**FRANK W. BALLOU SENIOR HIGH SCHOOL**

14 21 00-002

Elect Traction Elevator SD

Electric Traction Elevator Shop Drawings

**DWG. NO. 618625-PN**

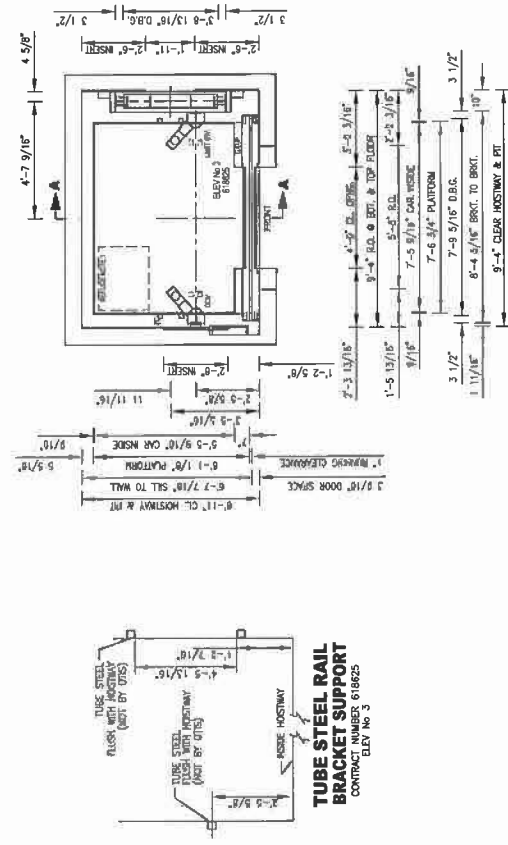
Hoistway dimensions for elevator #2 do not match basis of design. Contractor to coordinate edge of slab with structural.
